ATTACHMENT 2

PROPOSED TECHNICAL SPECIFICATION

Marked-up Technical Specifications Pages.

TURKEY POINT - UNITS 3 & 4

TABLE 3.3-3 (Continued)

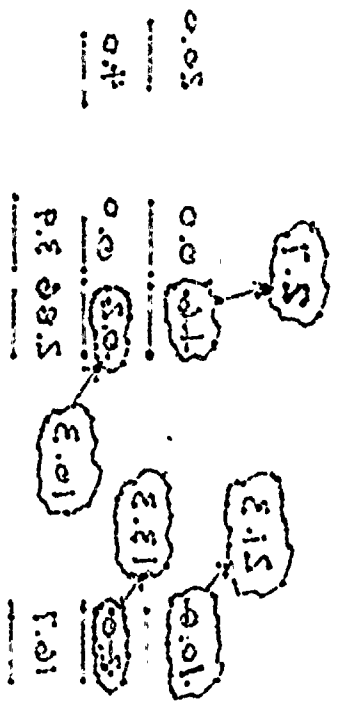
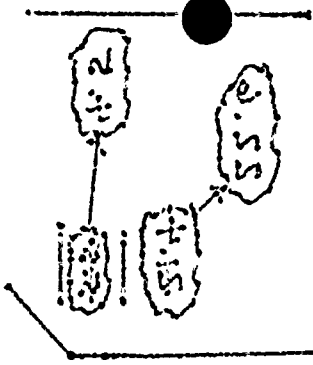
≤ A function defined as follows: A ΔP corresponding to 42.6% Steam Flow at 0% load increasing linearly from 20% load to a value corresponding to 122.6% steam flow at full load.

as follows: A Δp corresponding to 0.64×10^6 lbs/hr at 0% load increasing linearly to a Δp corresponding to 3.84×10^6 lbs/hr at full load.

40% steam flow
from 20% load to a value
120% steam flow
